SUBJECT: MEETING WITH VIRGINIA ELECTRIC AND POWER COMPANY (VEPCO)
AND GENERAL NUCLEAR SYSTEMS, INC. (GNSI)

PURPOSE: To discuss resolution of questions concerning the CASTOR V/21
cask basket originally raised in October 1985 during a
Department of Energy spent fuel storage demonstration using
a CASTOR V/21 cask at the Idaho National Engineering
Laboratory.

COMMENTS ON CASTOR V BASKET ANALYSIS

Test of Basket Welding SN 6

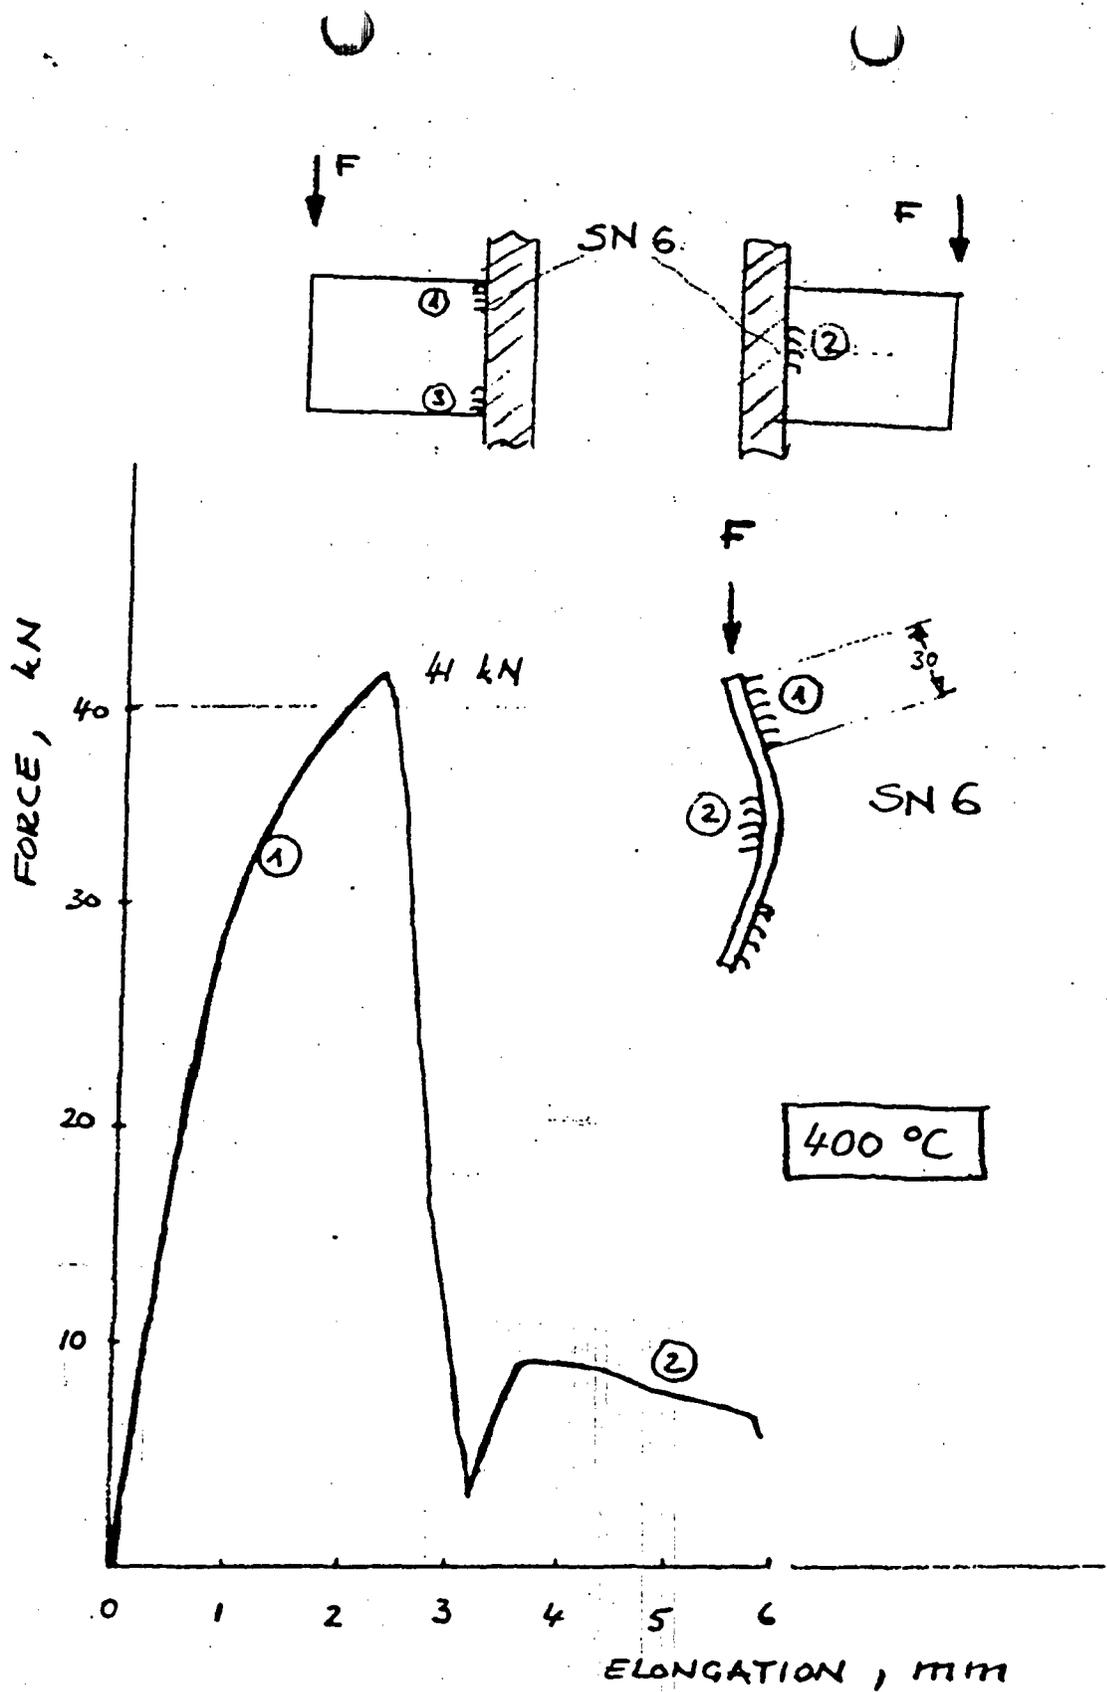
Develop failure analyses and criteria based on strain or displacement for J1, J2 and show how failure is related to acceptance criteria. Acceptance criteria includes ASME code case for low ductility austenitic steels.

Present discussion on how the G1, G2 gaps are assured by measurement and note tolerances.
